SPARTAN  MOTORS  
CHASSIS, INC.

CSB 00-0201A  
SPEC (00005)  
Page 1 of 4  
March, 2001

## CAMPAIGN SERVICE BULLETIN

**Door Latch Replacement**

**FIG. 2-1**

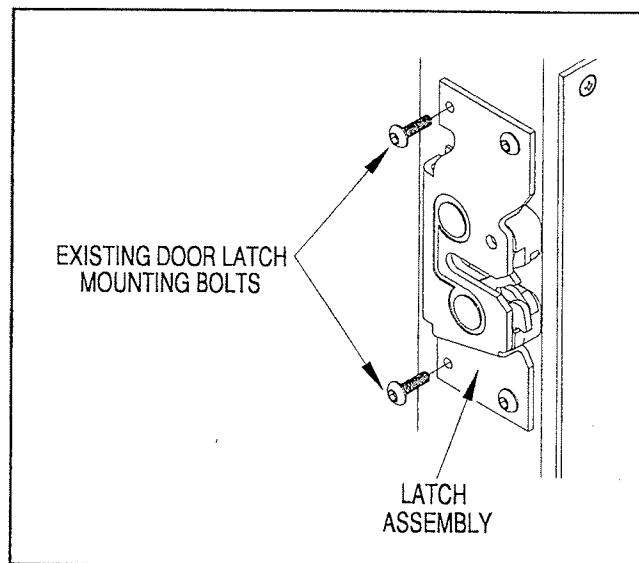
1. Refer to FIG. 2-1. Remove and properly dispose of the two- (2) most forward bolts from the door latch assembly as shown.

**FIG. 3-1**

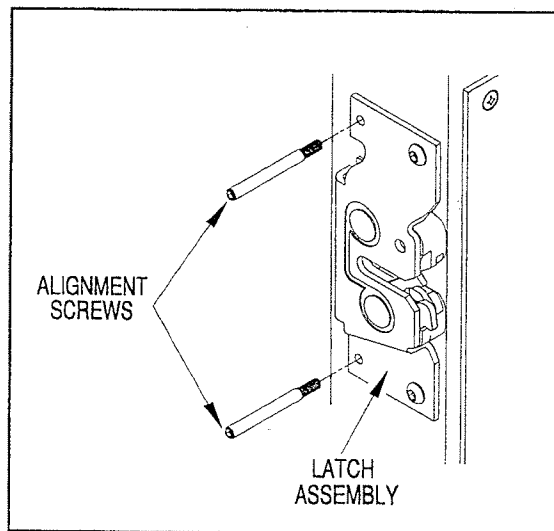
2. Refer to FIG. 3-1. Using the alignment screws provided in kit #00005, install one screw in each of the open holes from step #1 using a 1/8" hex key wrench.

**Note: Thread alignment screws into latch control mechanism approximately 1/2". These screws are the locating devices for the new door latch and the inside latch control mechanism.**

**FIG. 4-1**

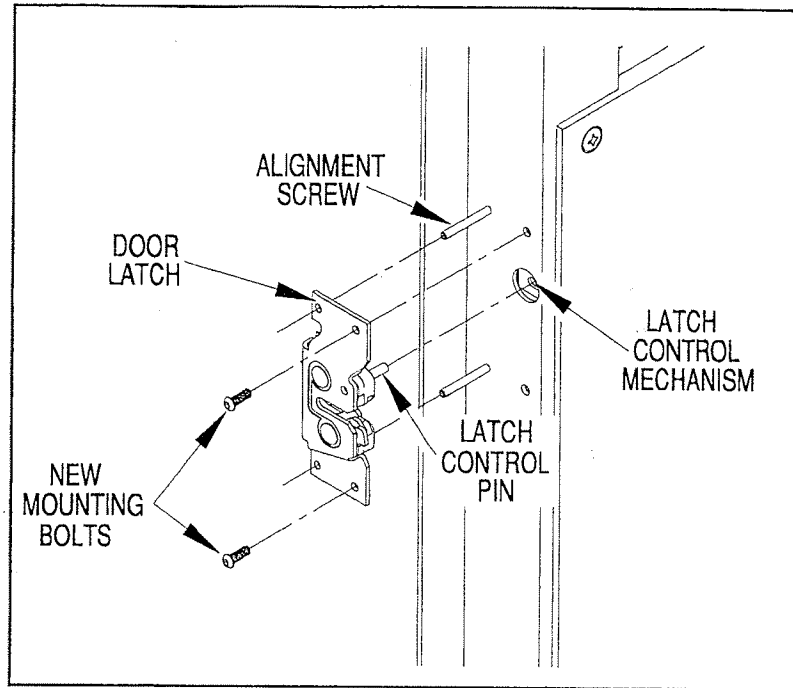
4. Refer to FIG. 4-1. Using the alignment screws, position the new door latch to the door frame as shown.

**Note: The latch control pin must be engaged properly into the latch control mechanism.**

5. Install new mounting bolts. ***New mounting bolts with new locking patch must be installed.*** Secure each bolt to a torque range of 96-120 IN LBS.
